Incorrect Thermal broken Aluminum Joinery: 2 Rapare St. Job No.27363 - JSR Construction.

Harry Lo <harrykhlo@gmail.com>
To: Ricky Wong <jsrconstruction.nz@gmail.com>
Cc: Sze Ping Jessica Lo <jlee2609@yahoo.com.hk>

Sun, Nov 20, 2022 at 10:06 PM

Figure 1 - Photo location plan

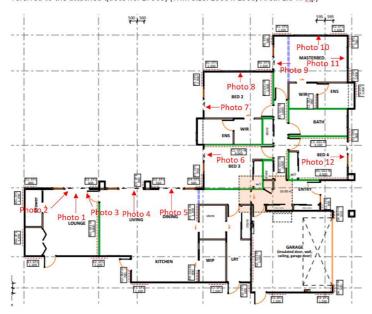
You shall provide us with all the satisfied up-to-standard thermally broken aluminium joinery. You are requested to replace and re-install all the incorrect entire windows and doors. Partly replacement of aluminium materials on the site is not acceptable. You are also liable for all our losses of cost including but not limited to the related the matters of any material reinstatements, any material variations, any time delay and any opportunity costs incurred by the correction of the aluminium windows and doors. The incorrect and uncertain products are stated below with the corresponding photos and the photo location plan (Figure 1 below). The product quote no. 27363 from your subcontractor is attached for your reference.

- 1) The parts of the windows and doors frames do not have the thermally broken strip. These windows and doors make up 59% of the area of all the aluminium joinery products. The total area of these problematic aluminium joinery is 28.8 m sq. The total area of all aluminium joinery products is 48.6 m sq. These problematic products are shown in the following photos (note that the photos and the location plan are given at the end of this email):

- 2) The frames of the windows that we are not sure if they are thermally broken or not since the depths of those window frames seems to be smaller than others 32% of the thermally broken joinery by comparing the distances between the frames and the internal and external walls. The total area of these uncertain aluminium joinery is 4.2 m sq. (8.7 % of the total area). These products are shown in the following photos:
